01-31-'05 18:39 FROM-Lerner & Greenberg
Applic. No.: 10/082,049
Amdt. Dated January 31, 2005
Reply to Office action of November 5, 2004

Amendment to the drawings:

REMARKS/ARGUMENTS

FIG 1

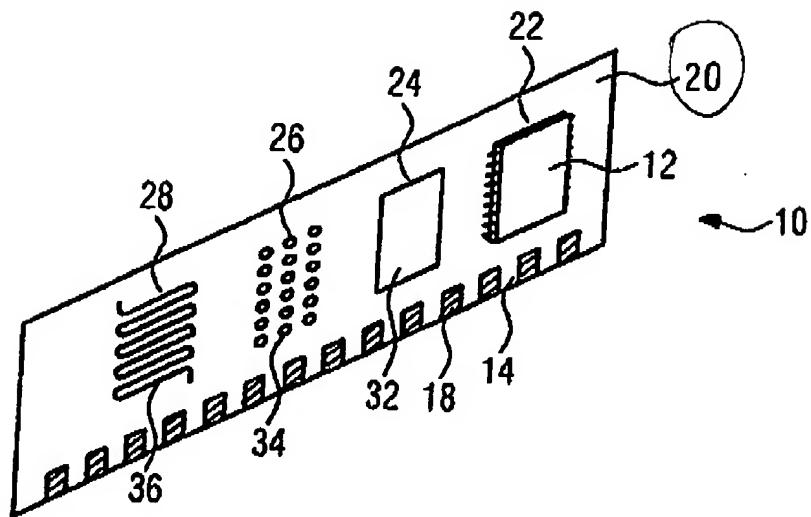
In item 2 on page 2 of the above-identified Office action, the drawings have been objected to under 37 CFR 1.84(p)(5) as not showing the reference sign 20 mentioned in the specification.

The attached sheets of drawings include changes to Figs. 1-3. These sheets replace the original sheets. In Figs. 1 and 2, previously omitted reference sign 20 has been added. In Fig. 3, a legend --Prior Art-- has been added.

The reference sign 20 has been added to Figs. 1 and 2.

FIG 3

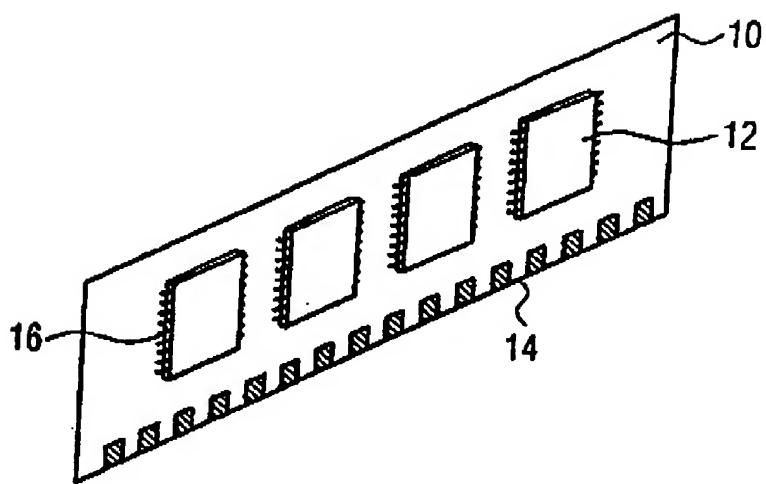
In deference to the Examiner's requirement in item 1 on page 2 of the Office action, a legend --Prior Art-- has been added to Fig. 3.
